### **Council File Number 15-0317-- Case No. BF 140090 Appeal for 3923-3941 North Hopevale Drive**

Re: Council File No. 15-0317 - Case No. BF 140090  
3923 – 3941 Hopevale Drive – Haul Route Appeal

### **GRADING QUANTITY STUDY FOR 3923 HOPEVALE DRIVE CITY OF LOS ANGELES APRIL 10, 2015**

SHEET NO.  
1  
OF 1 SHEETS

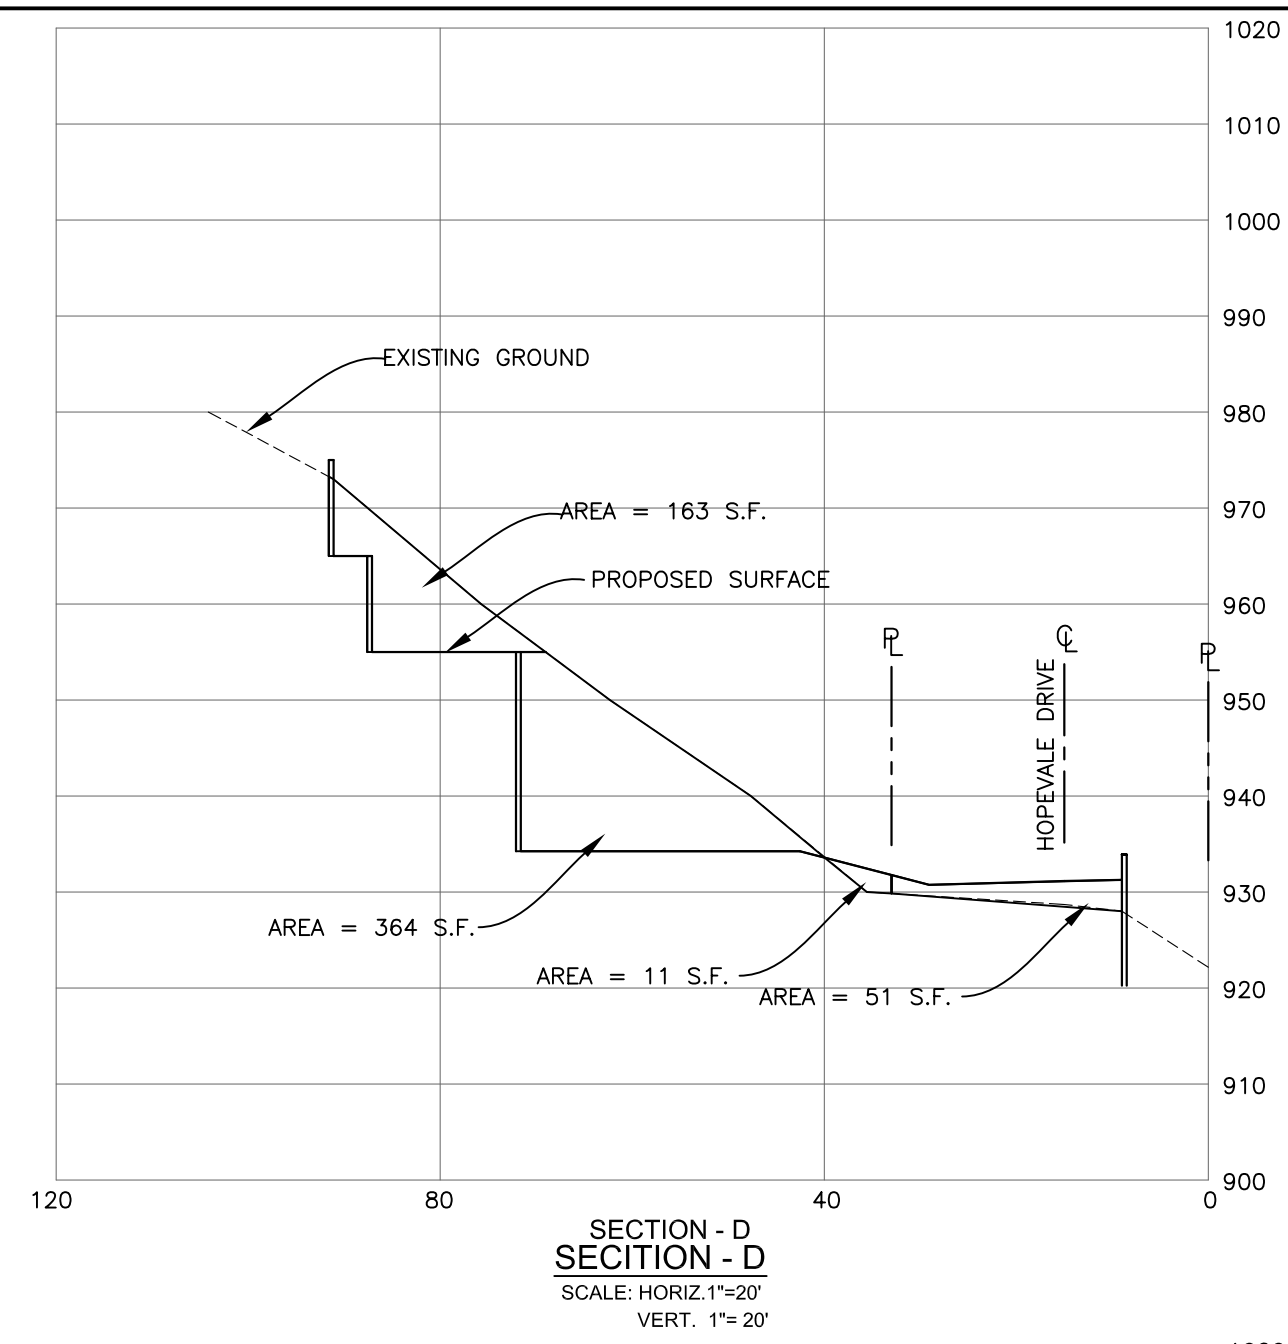
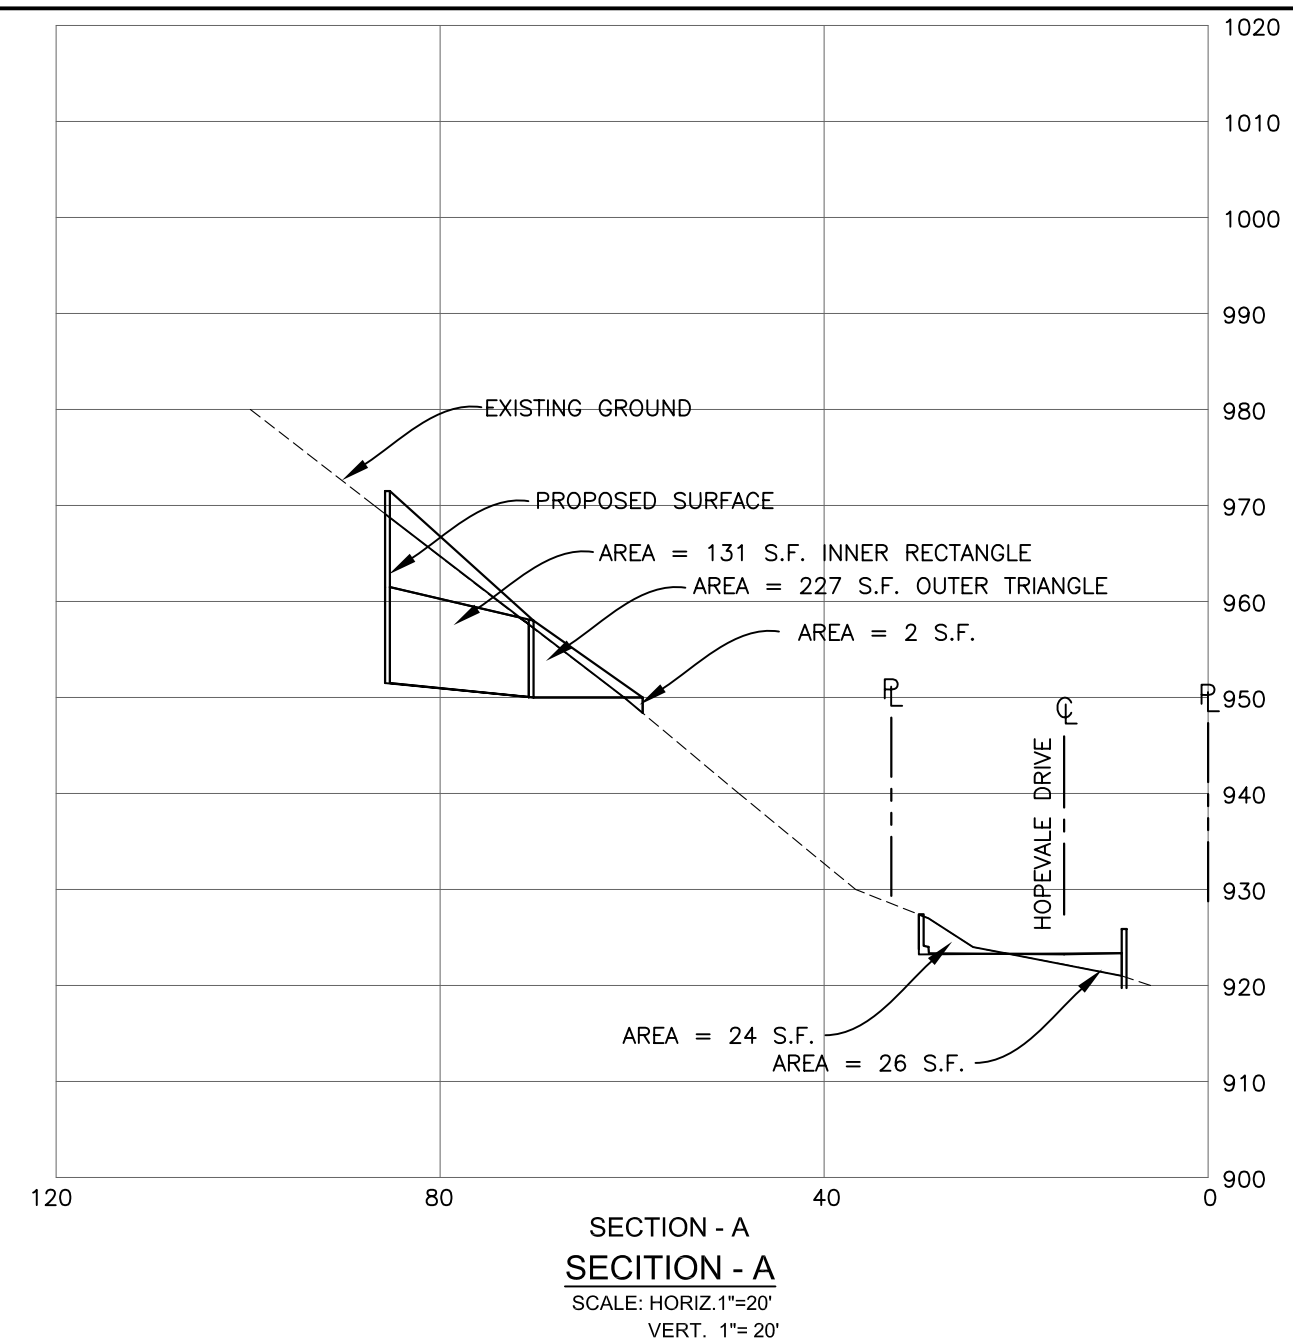
**NOTE**  
THE EXISTING GRADE SURFACES SHOWN HEREON FOR ELEVATIONS 928 AND BELOW (IN THE STREET AREA) WERE TAKEN FROM APPROVED STREET PLAN P-36633 AND DO NOT MATCH THOSE SHOWN ON THE PROPOSED GRADING PLAN. THE EXISTING GRADE SURFACES SHOWN HEREON FOR ELEVATIONS 930 AND ABOVE WERE TAKEN FROM THE PROPOSED GRADING PLAN.
